**Class 1\* Permit Modification Request**  
**Change to Closure Schedule for Panels 1 through 8**  
**Waste Isolation Pilot Plant**  
**Carlsbad, New Mexico**  
**WIPP HWFP #NM4890139088-TSDF**  
**January 2007**

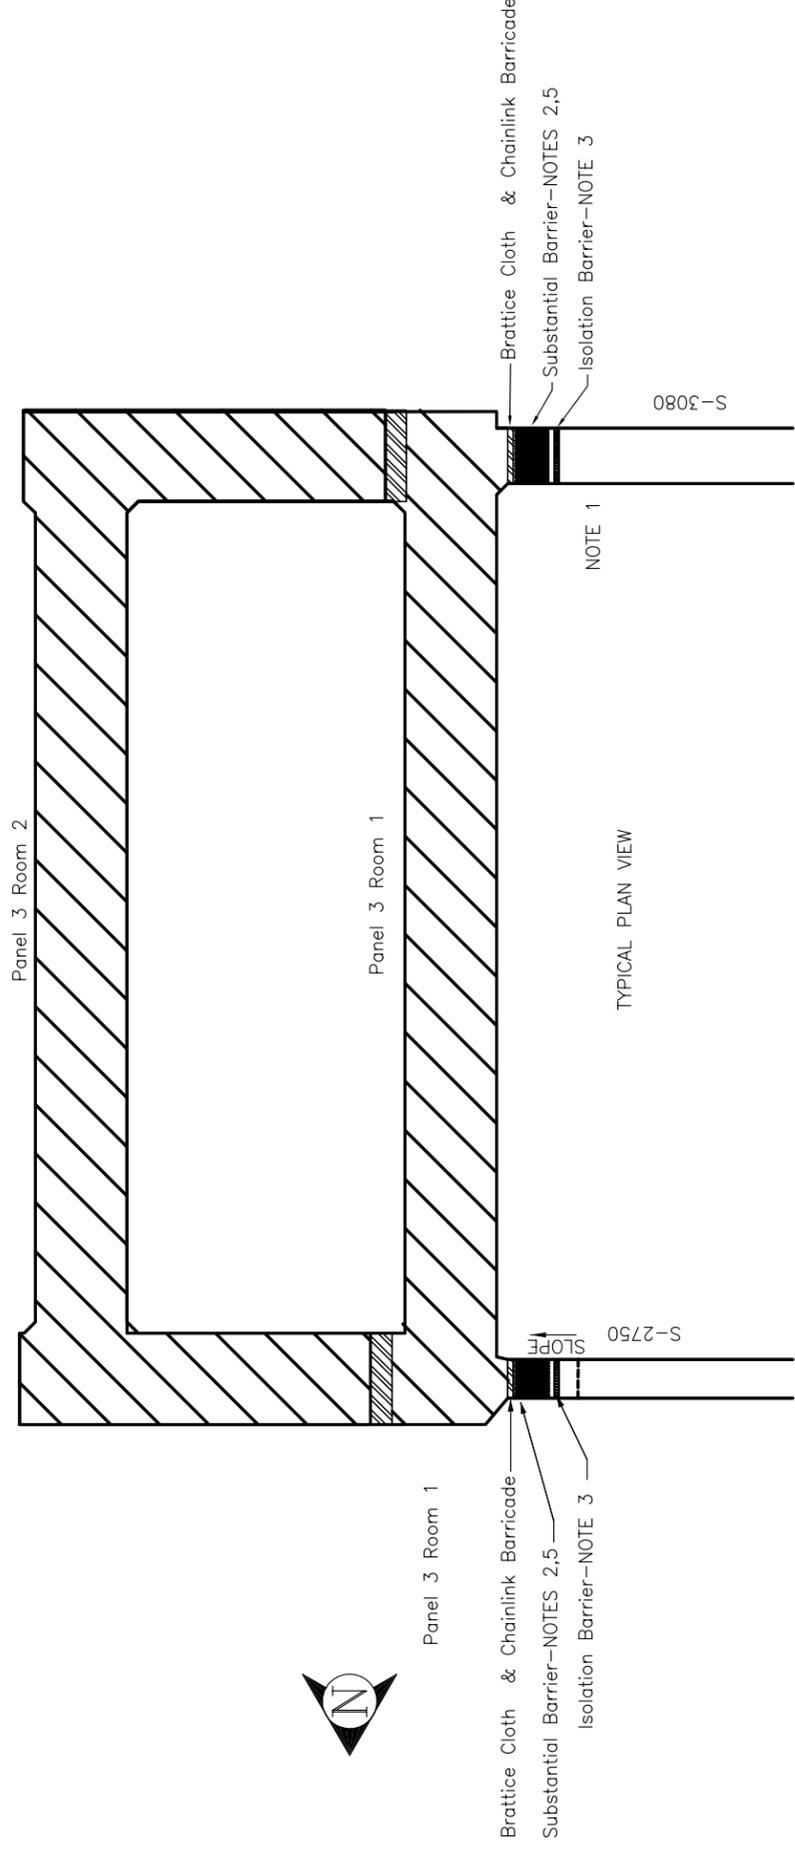
Steel bulkheads have been used in the WIPP underground since the first openings were mined over 20 years ago. Their primary function is to regulate or direct ventilation air and to isolate different air streams from each other. While the WIPP openings creep and close, bulkheads are designed to accommodate such movement by their construction. Although the center portion of the bulkhead is constructed of rigid steel panels, this is supported and connected to the surrounding mine opening with supports that automatically adjust by sliding in their mounts. These supports are typically designed to have about 18 inches of available adjustment. In addition, flexible flashing is installed to provide a ventilation seal between the rigid center and the mine openings (see Figure B).

FIGURE A—TYPICAL LAYOUT  
PANEL SUBSTANTIAL AND ISOLATION BARRIERS

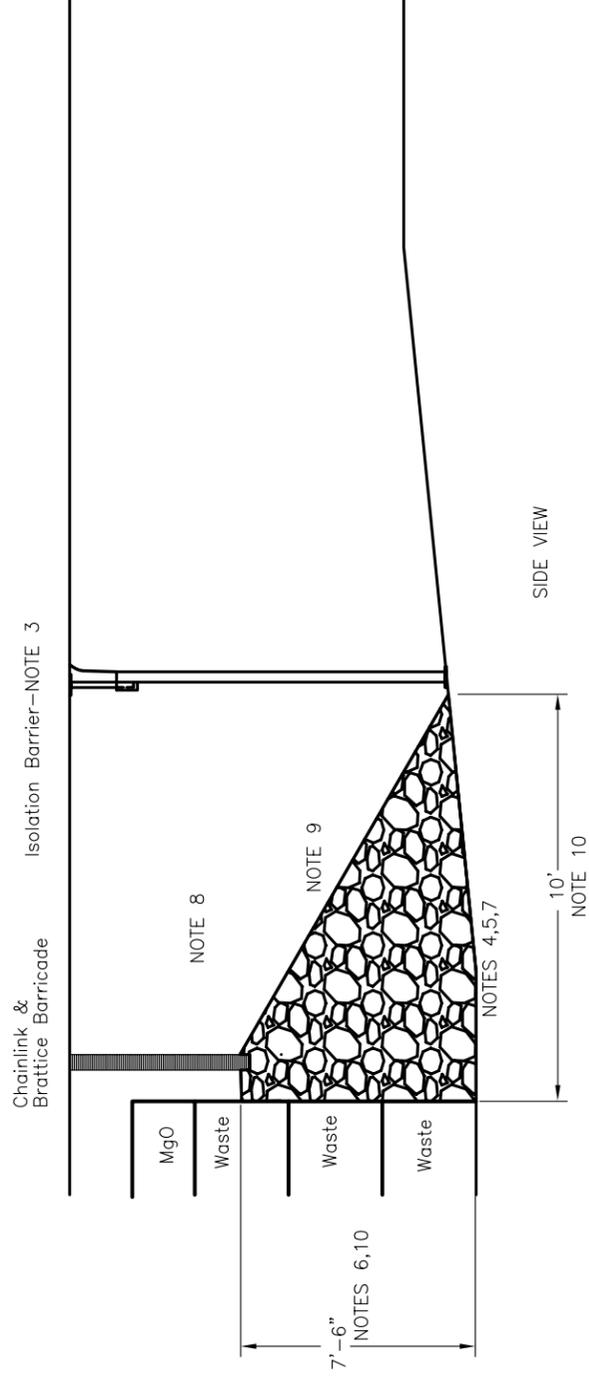
The substantial barrier serves to protect waste from events such as ground movement or vehicle impacts. The barrier will be constructed from available materials such as magnesium oxide or mined salt (see Figure A).

1. A SUBSTANTIAL BARRIER AND ISOLATION BARRIER INSTALLATION WILL BE INSTALLED IN THE INTAKE AND EXHAUST DRIFTS OF THE PANEL. THE EXACT CONFIGURATION OF THE INSTALLATION WILL BE DEPENDENT ON THE AS-FOUND CONDITIONS OF THE DRIFTS.

2. CONFIGURATION AND PLACEMENT OF THE SUBSTANTIAL BARRIER WILL BE DICTATED BY FIELD CONDITIONS.
3. TYPICAL ISOLATION BARRIER IS DEPICTED ON FIGURE B.
4. AMOUNT AND HEIGHT OF THE SUBSTANTIAL BARRIER WILL BE DETERMINED BY THE COGNIZANT ENGINEER, BASED ON FIELD CONDITIONS.
